Consultation Response from KC, Highways Development Management
2026/91304 Rose And Crown Inn, 132, Knowl Road, Golcar, Huddersfield, HD7 4AN
Variation condition 2 (plans) 9 (drainage), 10 (drainage), 14 (highways) and 17 (provision of footway) on previous permission 2024/90839 for erection of 7 dwellings and associated infrastructure following partial demolition of existing public house (within a Conservation Area)
Date Responded: 24 June 2026 Responding Officer: Sheila Henley Responding Ref: 2-3NE/18

Recommendation: Additions and revisions.

Plan Ref: 3683 (0-) 10C Proposed Site Plan; 2376-0007 rev B - Highway Boundary; 2376-0006A - Bus Shelter; 2376-0005B - Typical Sections; 2376-0004A - Cross Sections; 2376-0003A - Long Sections; 2376-0002B – Contours; 2376-0001E - Kerbing & Surfacing; 3683 (0-) 08B - Plot 6; 3683 (0-) 09C - Plot 7.

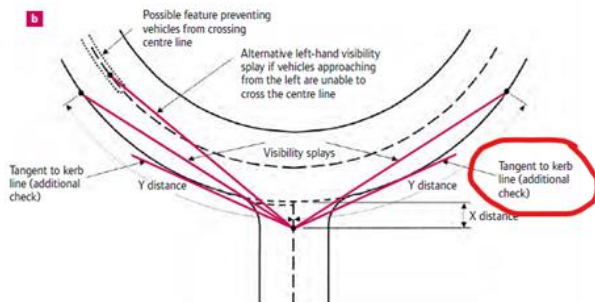
On the highway boundary plan there are no visibility splays indicated at the junction to the existing road however the 2.4m x 43m splay to the west also requires the secondary visibility splay as the junction is located to a bend as per the extract below from Manual for Streets.

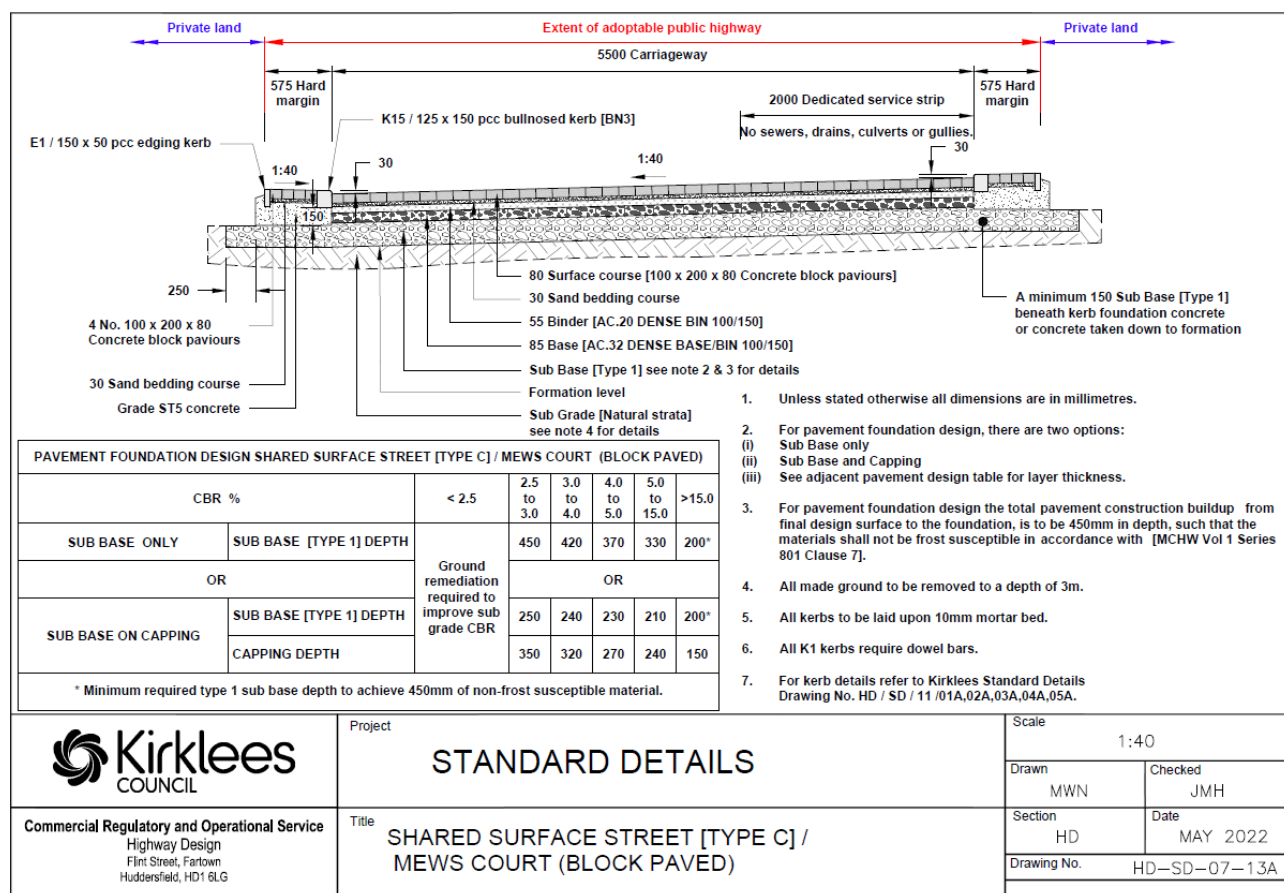
Junction visibility splays will also be required for the junction with the first spur of the turning head, Road B, as below:
